VIRGINIA ELECTRIC AND POWER COMPANY
RICHMOND, VIRGINIA 23261

January 26, 1993

VIRGINIA ELECTRIC AND POWER COMPANY
SURRY POWER STATION UNITS 1 AND 2
SECOND TEN YEAR INSERVICE INSPECTION INTERVAL
RELIEF REQUESTS

**Surry Units 1 and 2
ISI Relief Requests**

| INSERVICE INSPECTION DETAIL DRAWING REACTOR COOLANT PUMP-1-RC-P-1A SURRY POWER STATION UNIT 1 VIRGINIA POWER | | | |

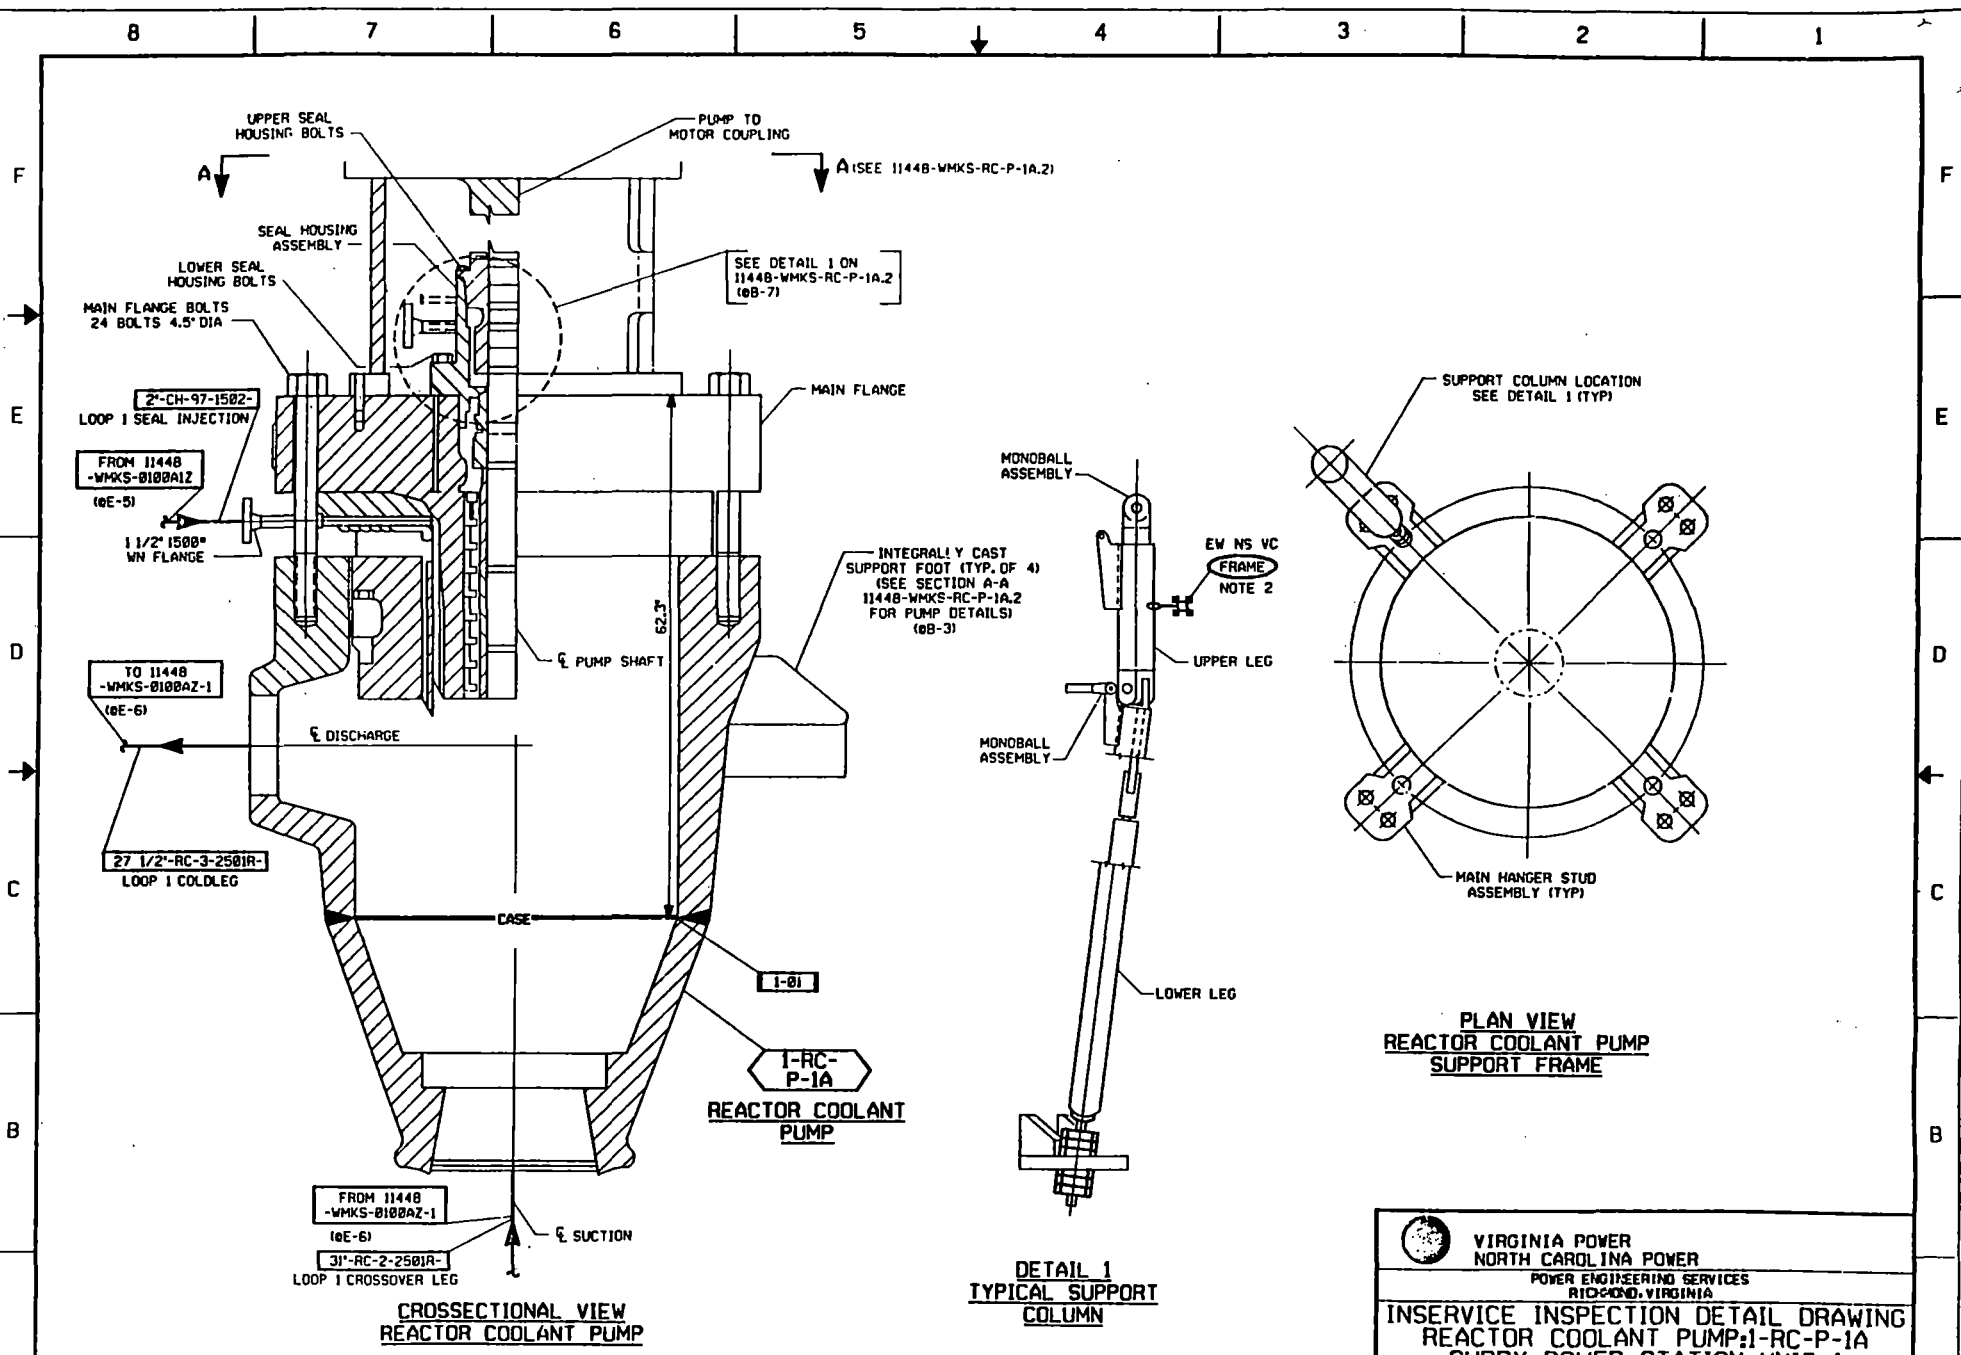
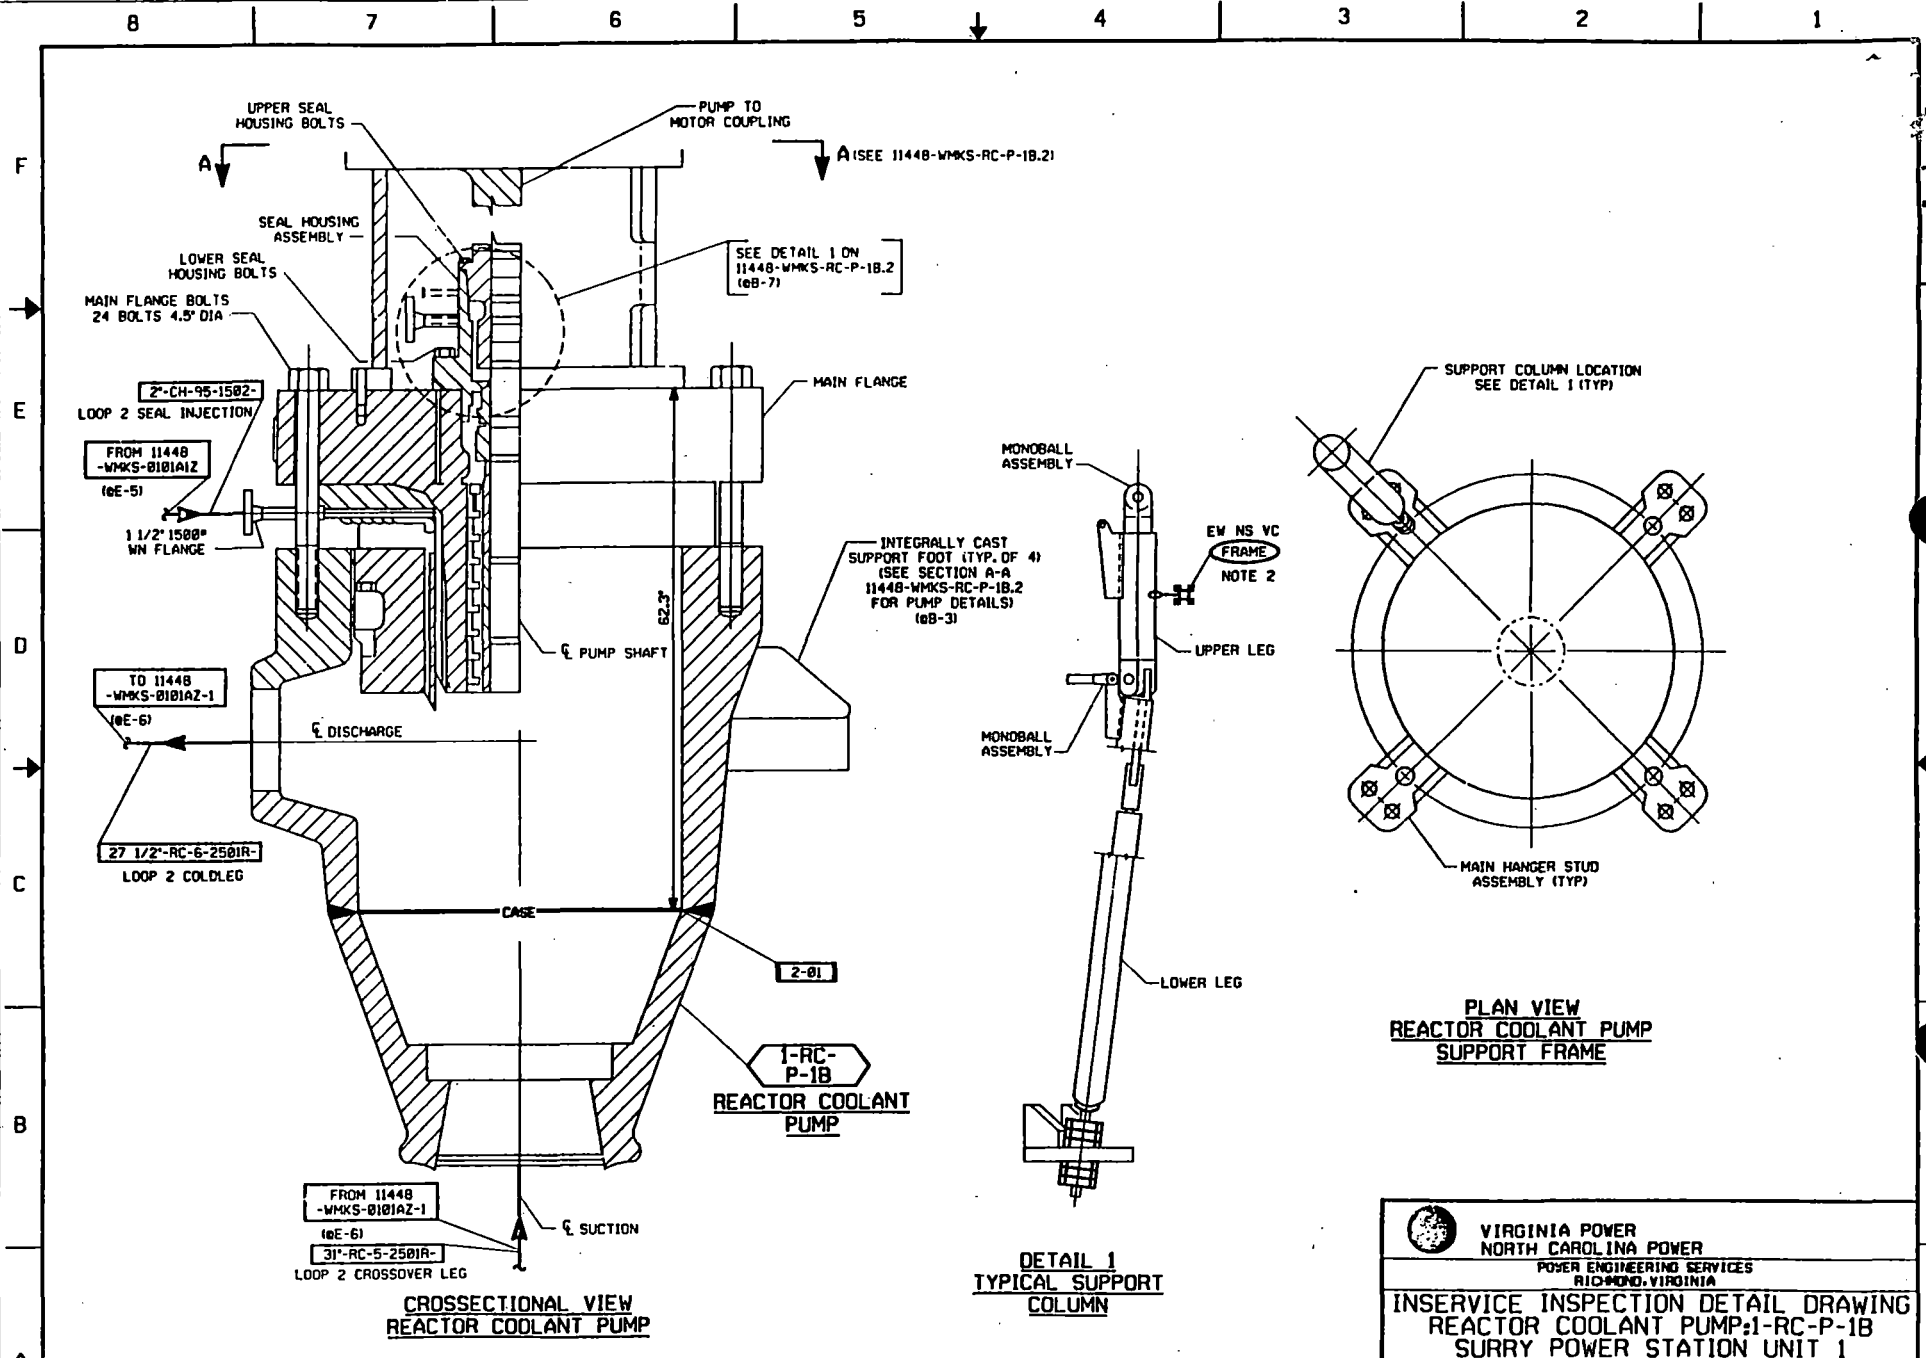
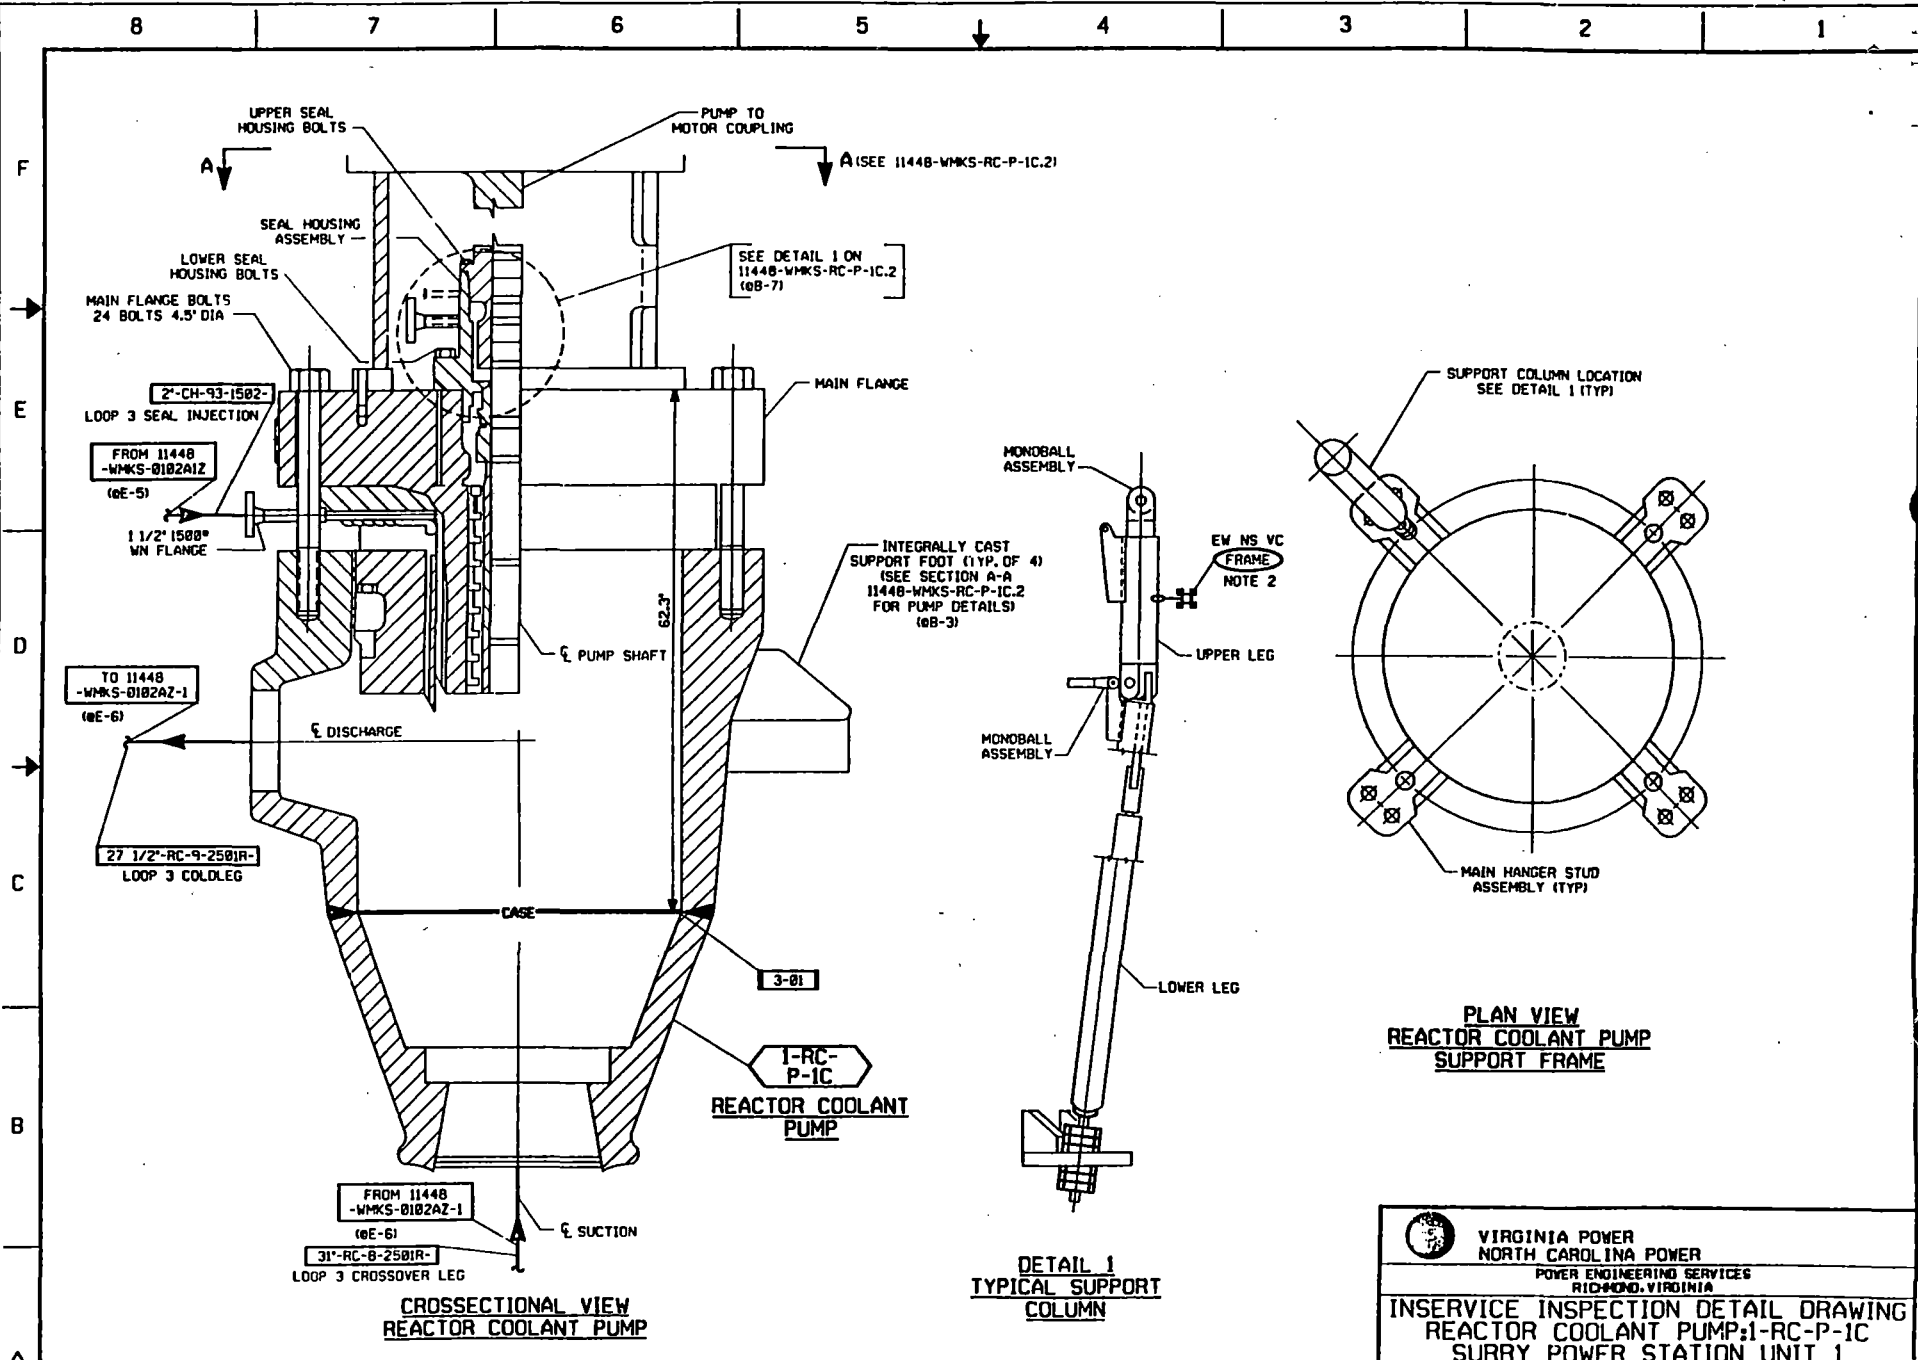
Category B-L-2, Pump Casings, Item number B12.20 requires a visual, VT-3, examination be conducted on the pump casing internal surfaces of one pump performing similar functions.

Performance of the Code required visual examination requires that the pump be disassembled to allow access to the pumps internal surfaces. Previously this examination was scheduled in conjunction with the Code required volumetric examination on the pump casing weld, which also required pump disassembly. Code Case N-481, Alternate Examination Requirements for Cast Austenitic Pump Casings Section XI, Division 1, will be used in lieu of the volumetric examination required by Table IWB 2500-1, Category B-L-1, Item B12.10. Requiring pump disassembly for the Code visual examination is impractical considering the cost and dose required to perform this action.

A technical evaluation addressing the safety and serviceability of the pump casing has been performed and separately submitted to the NRC on October 26, 1992 (Serial# 92-671) as required by Code Case N-481. The alternate inspection requirements will be implemented, which includes the performance of a VT-3 visual examination of the internal surfaces, whenever the pump is disassembled for maintenance. This requirement is similar to the provisions of the 1989 Edition of ASME Section XI in Table IWB-2500-1, Category B-L-2.

| INSERVICE INSPECTION DETAIL DRAWING OUTSIDE RECIRC SPRAY PUMP; 1-RS-P-2B SURRY POWER STATION UNIT 1 VIRGINIA POWER | | | |

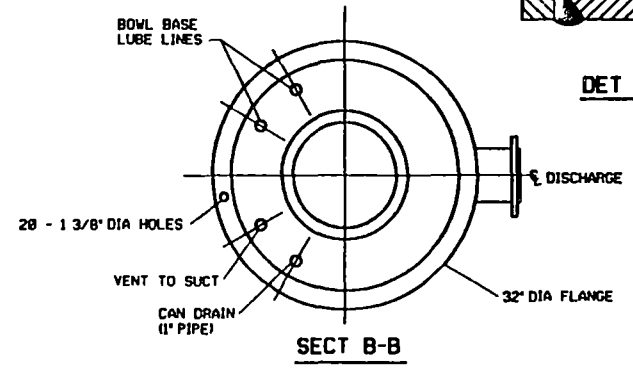
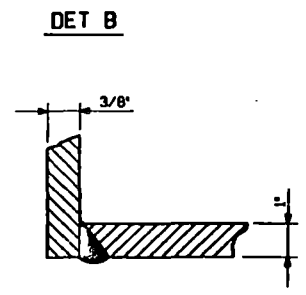
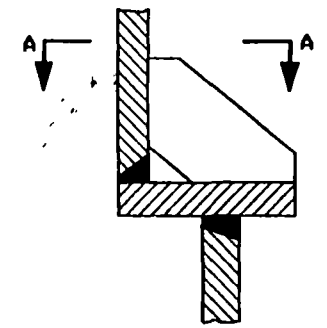
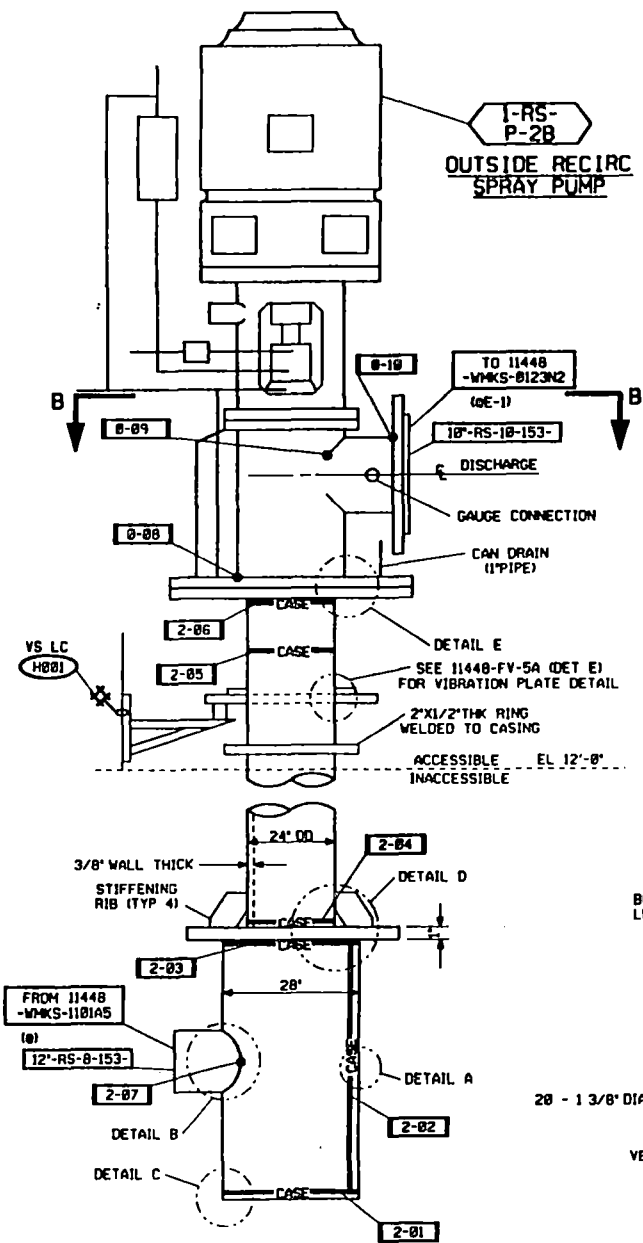
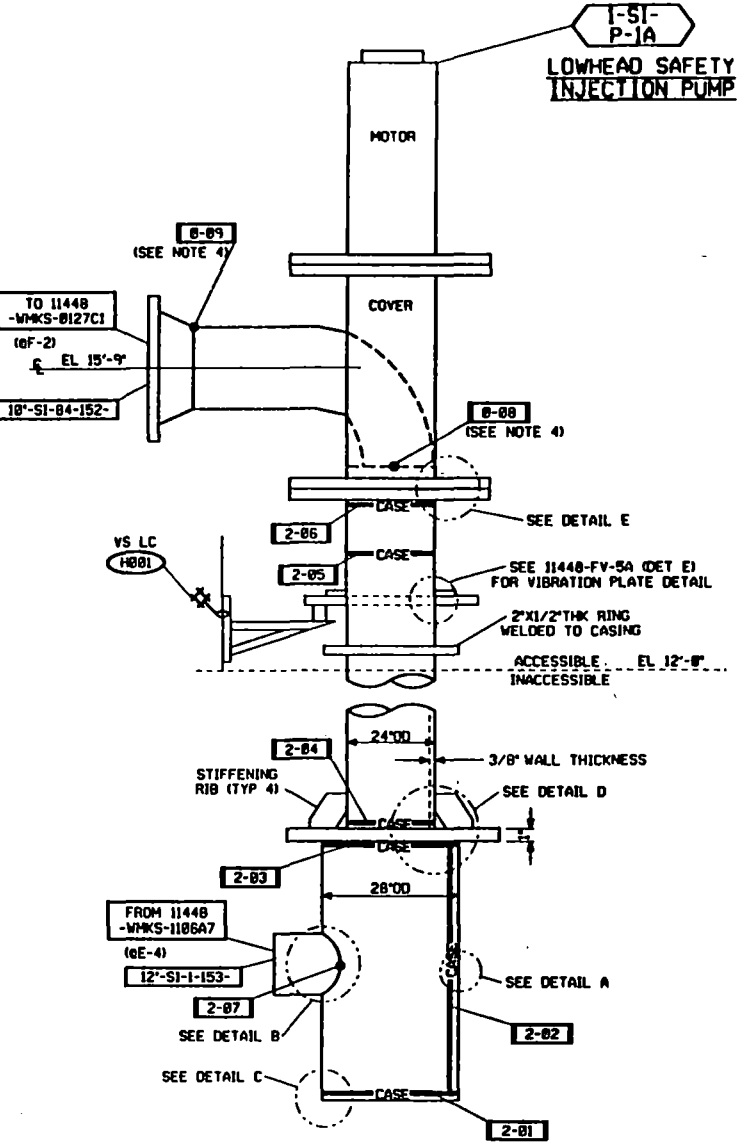
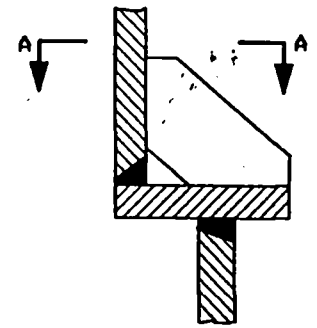
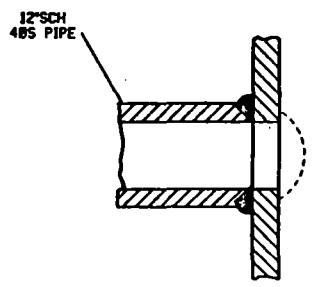
Category C-G, Item C6.10, Pump Casing Welds, requires that a surface examination be performed on 100% of the welds each interval. The examination can be limited to one pump in the case of multiple pumps of similar design, size, function, and service in a system.

These pumps are vertical, two-stage, centrifugal pumps, with an extended shaft and casing to allow suction from the containment sump. The motor and mechanical seals of the pumps are located at about the 12 foot elevation and the bottom of the casing at about the -30 foot elevation. The welds identified are at the bottom of the pump casing, and are embedded within the concrete building structure. This makes the welds inaccessible from the outside. The small diameter of the casing (24 inch. O.D.) and the pump shaft prevent examination from the inside diameter.

A remote visual examination (VT-1) of the accessible portions of the I.D. of the pump casing welds will be performed only if the pump is disassembled and the pump shaft removed for maintenance.
